**HOWELL TOWNSHIP PLANNING COMMISSION
REGULAR MEETING**

A. Old Business:
- B. New Business:
 1. Kory Leppek, PC2025-01, Parcel # 4706-20-100-027, 4640 W. Grand River Ave.
 Preliminary Site Plan Review
 2. Renewable Energy Ordinance - Discussion

Site Plan Review For Howell Township, Michigan

Applicant:	Kory Leppek
Project Name:	Leppek Landscapes
Plan Date:	December 16, 2024
Location:	4640 W Grand River
Zoning:	Industrial Flex Zone (IFZ)
Action Requested:	Preliminary Site Plan Approval

LEPPEK LANDSCAPE INC.
 4640 W. GRAND RIVER AVENUE
 HOWELL TOWNSHIP, LIVINGSTON COUNTY, MI
 PRELIMINARY SITE PLAN
 POLE BARN PLAN

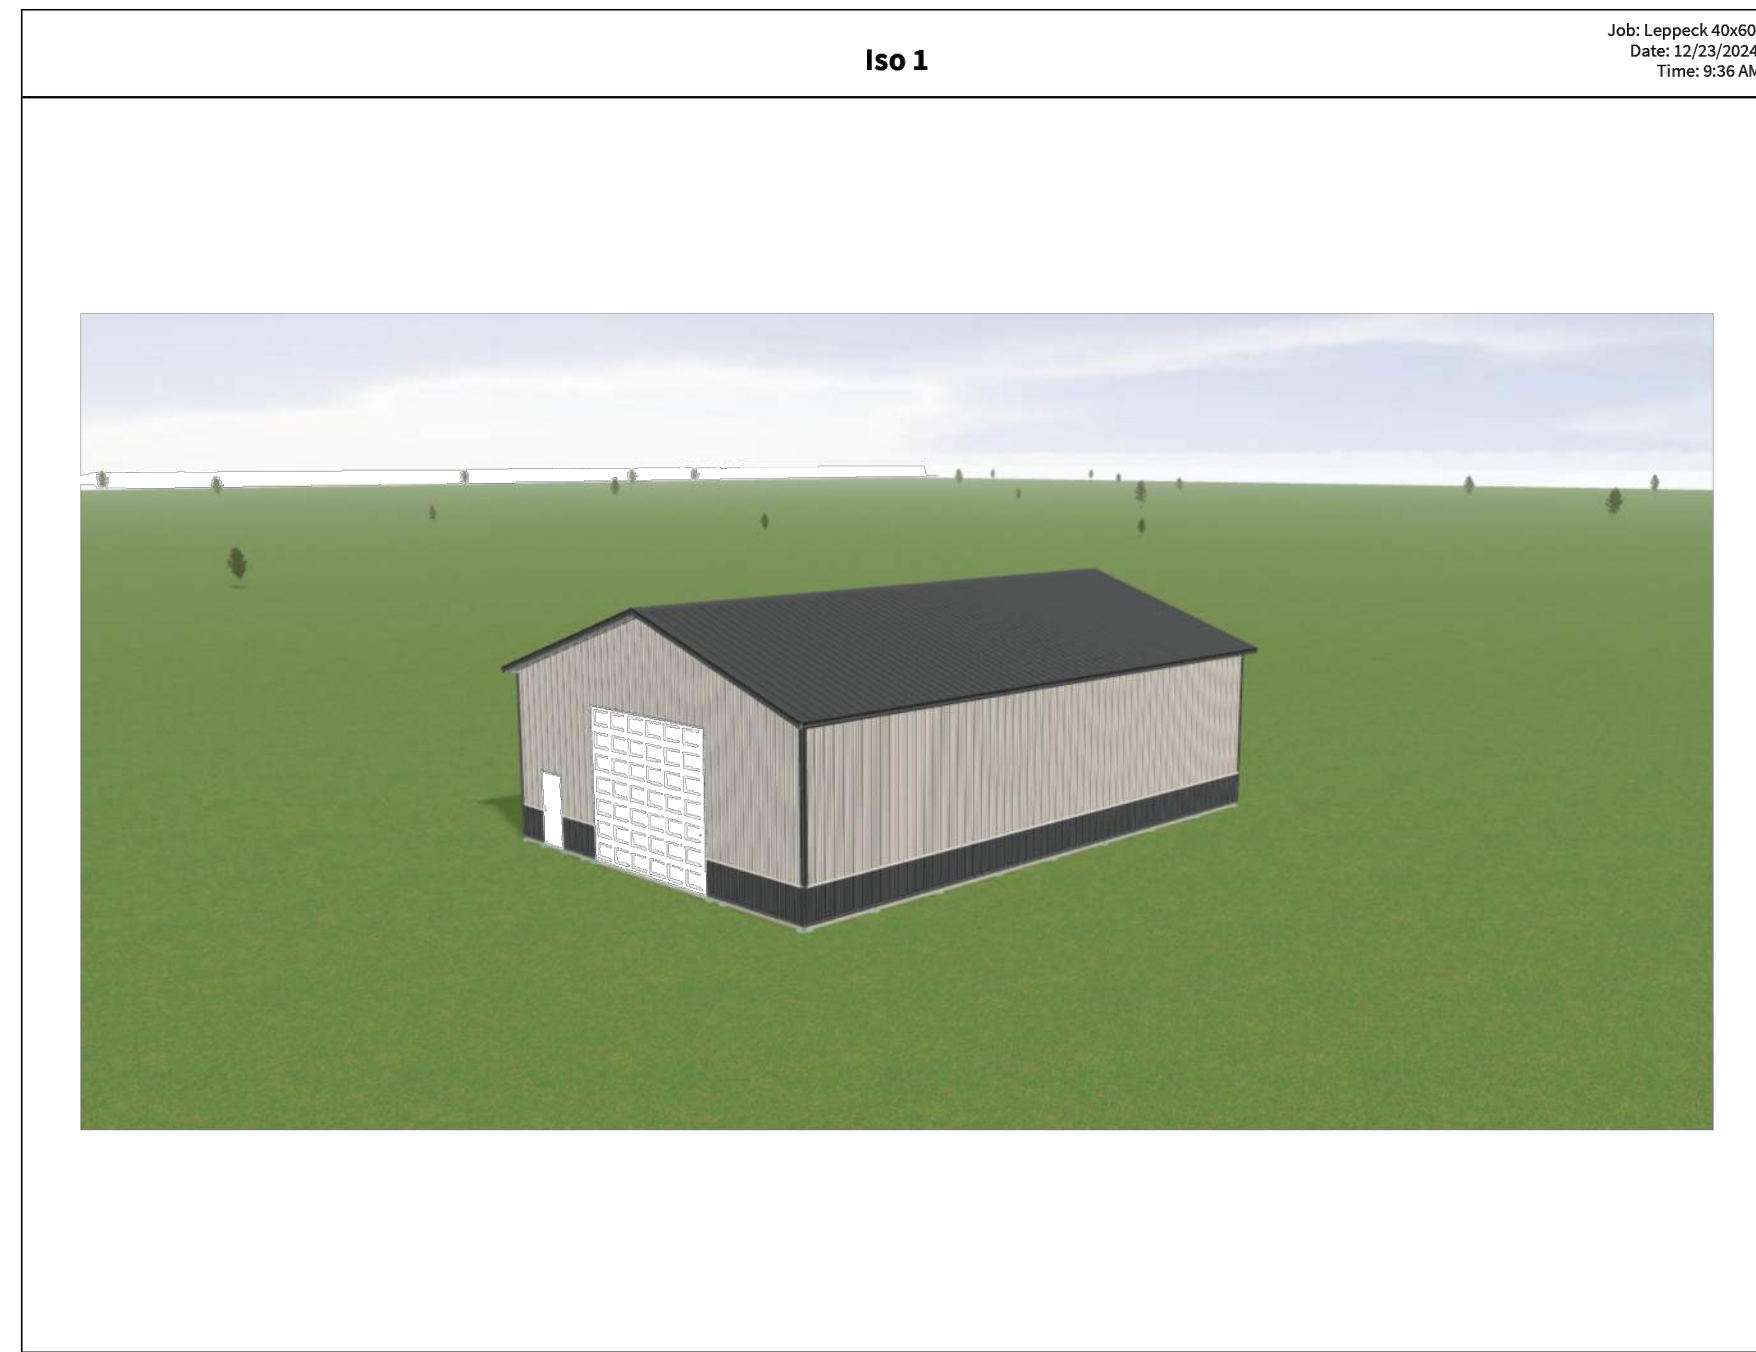
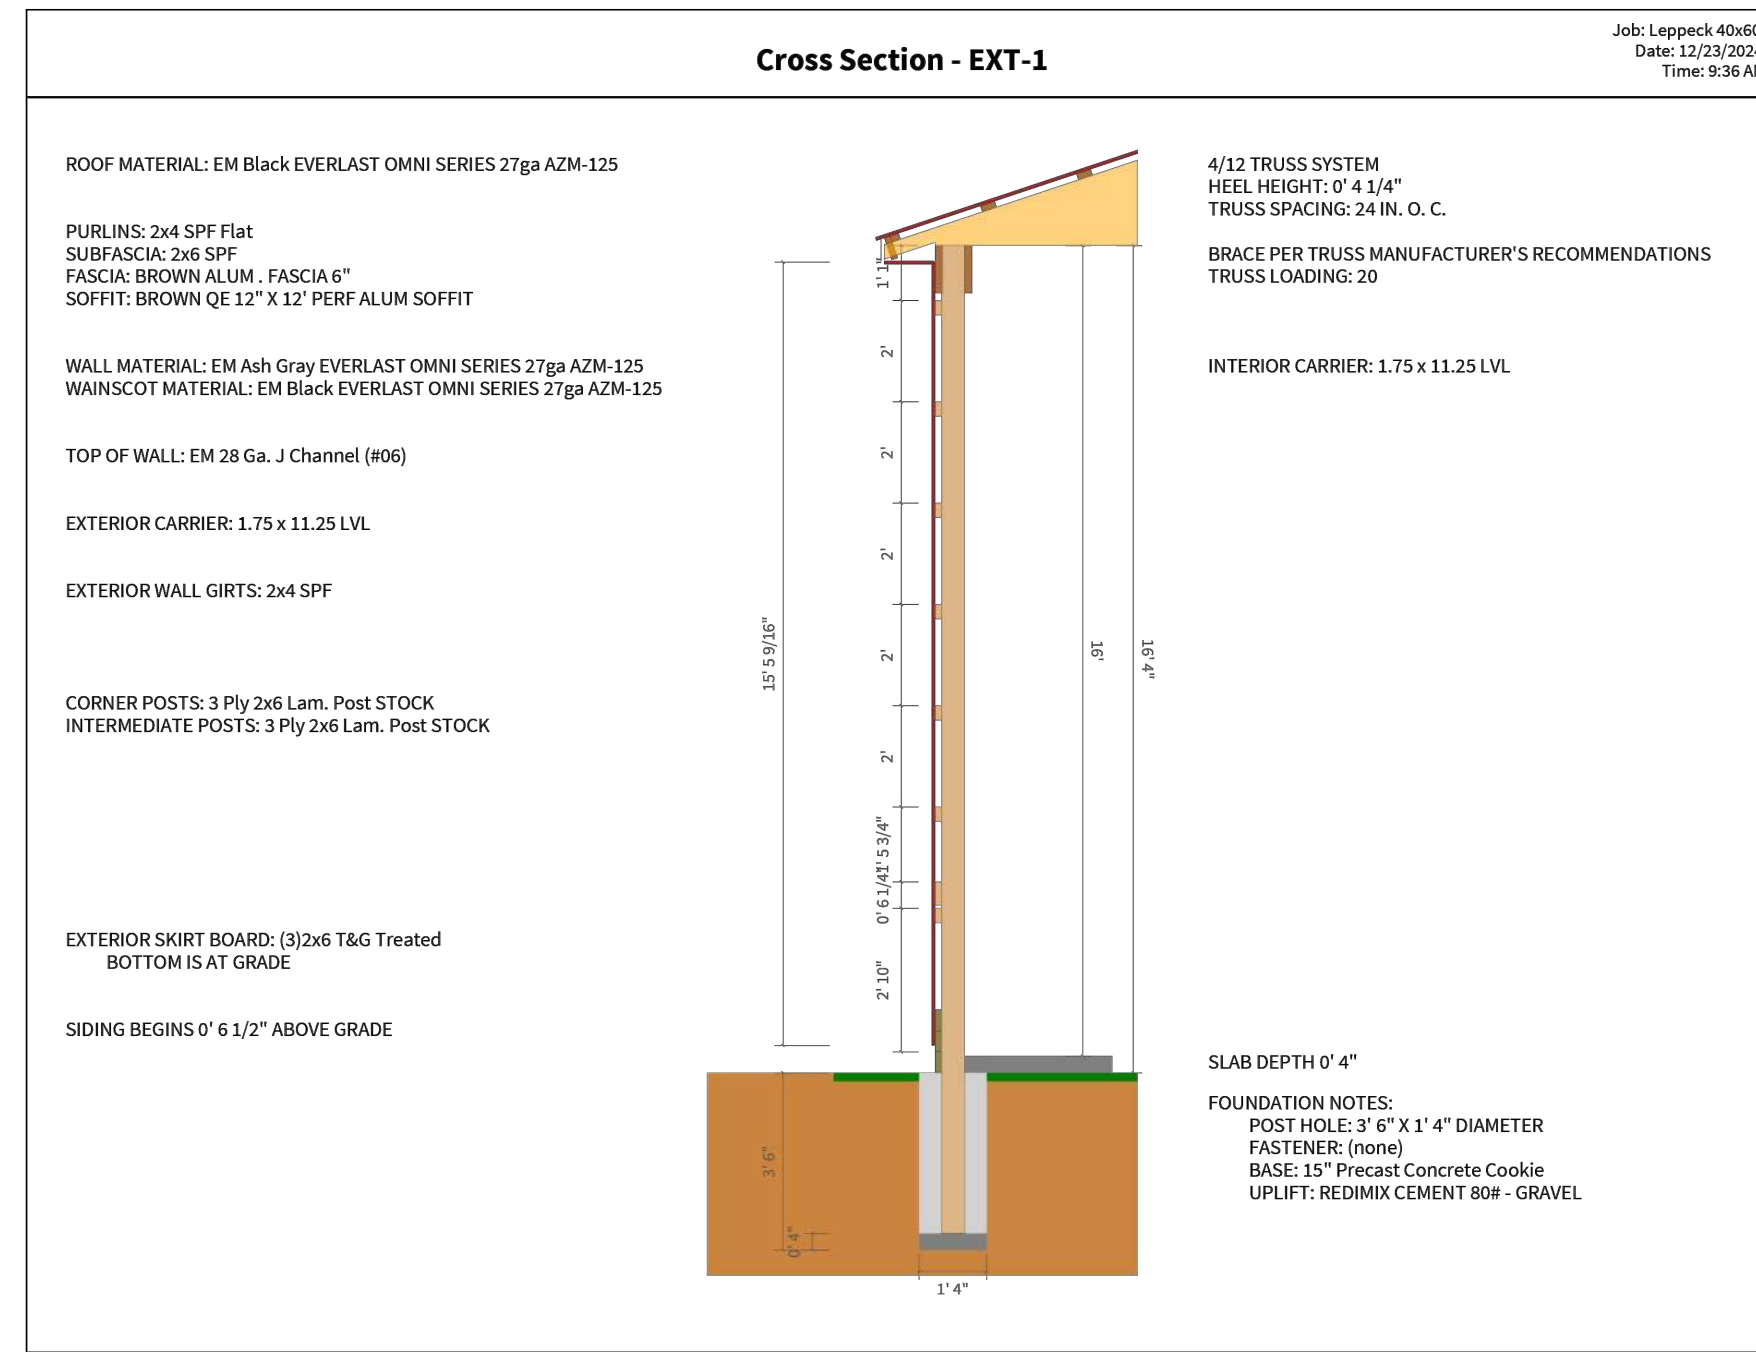
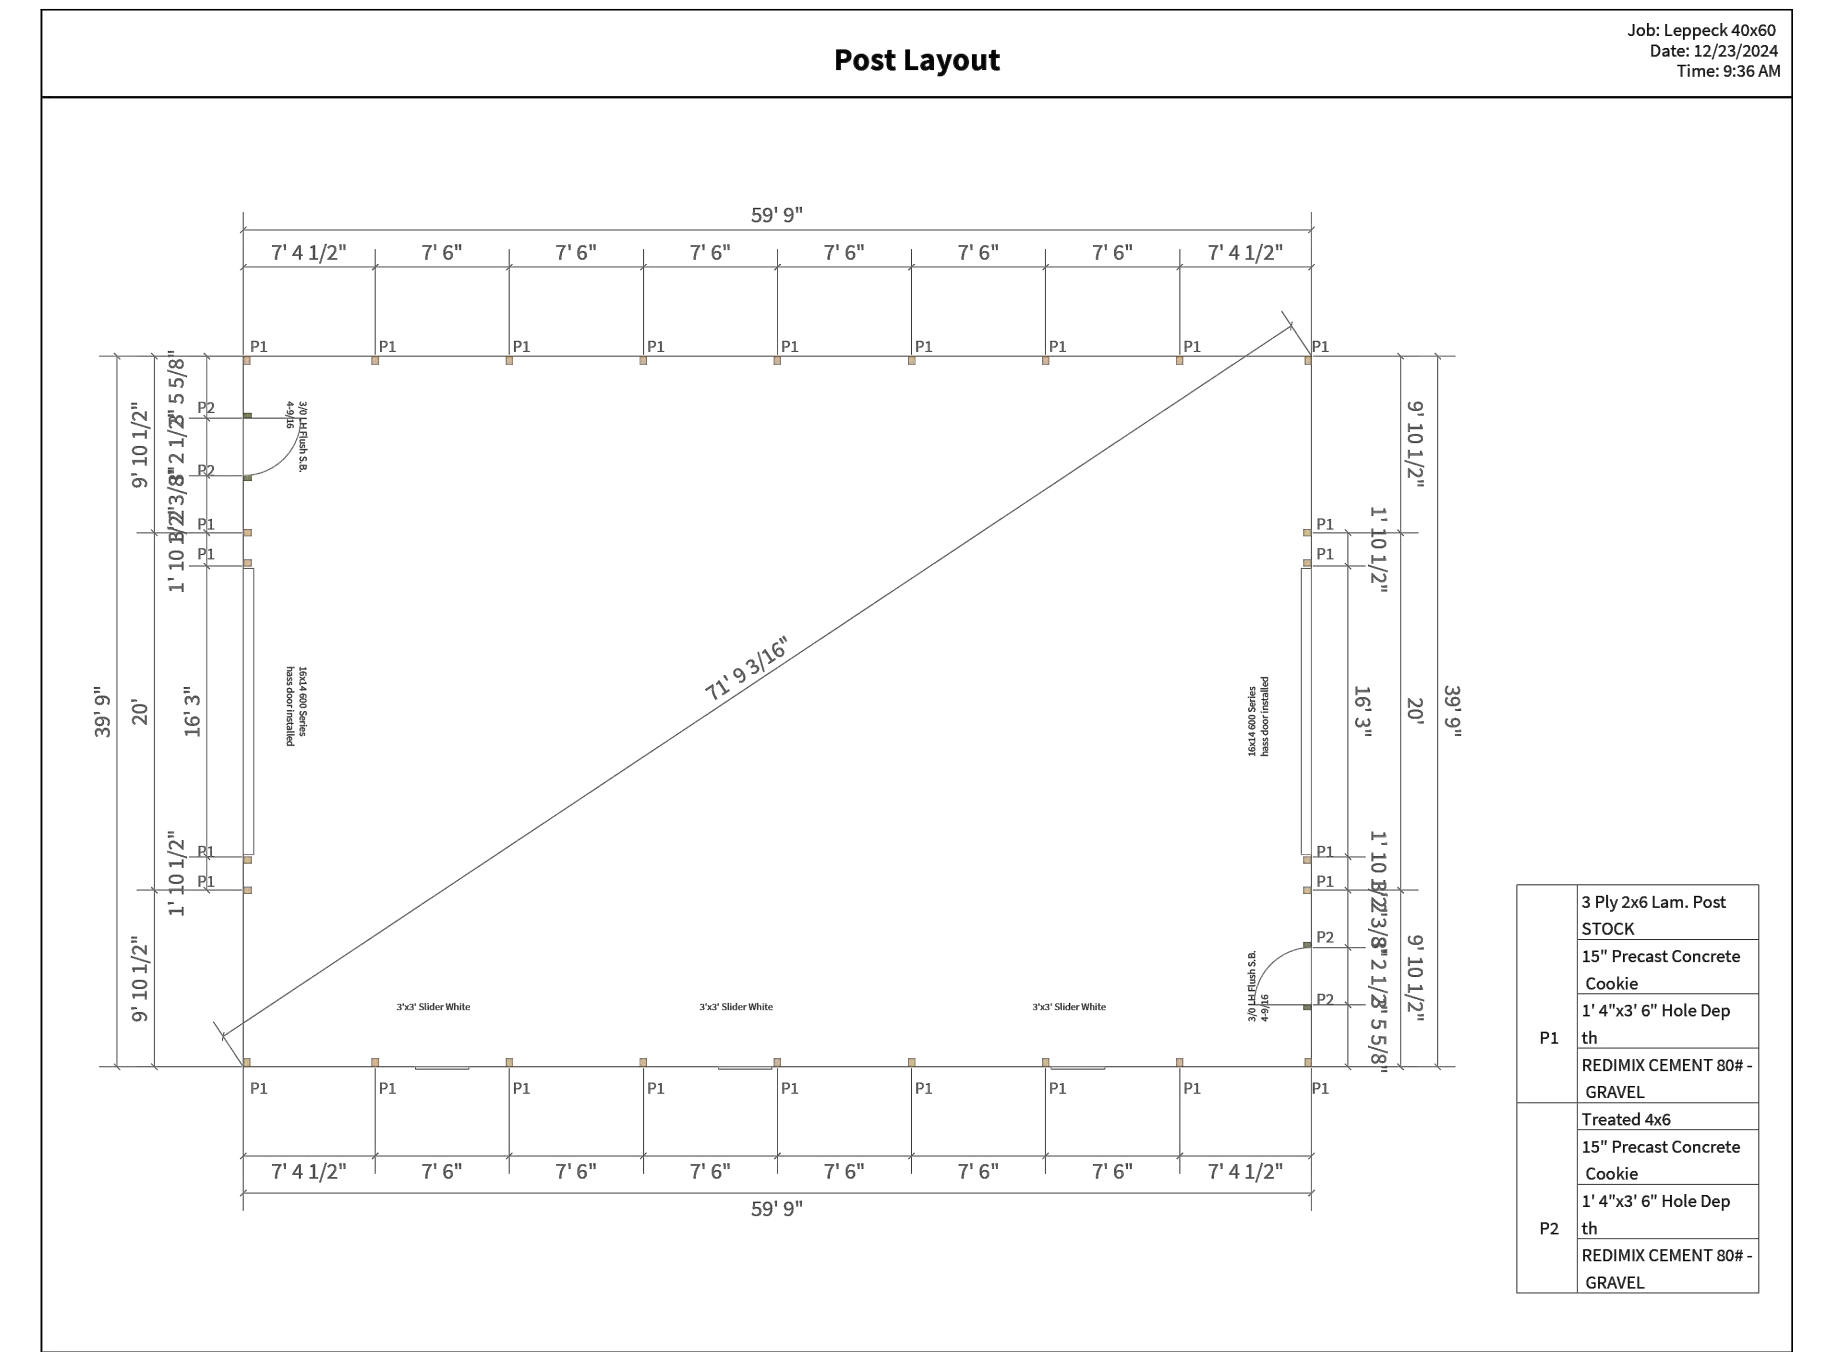
Insufficient floor plans and elevations have been provided on Sheet A-1. Elevations should be to scale and include building materials. A detailed floor plan showing the intended use of the proposed pole building should be included. Detailed floor plans and elevations for the existing building should be provided as well.

Items to be Addressed: *1) Provide scaled elevations for the proposed building. 2) Provide detailed floor plans for the proposed building. 3) Provide scaled elevations for the existing building. 4) Provide detailed floor plans for the existing building.*
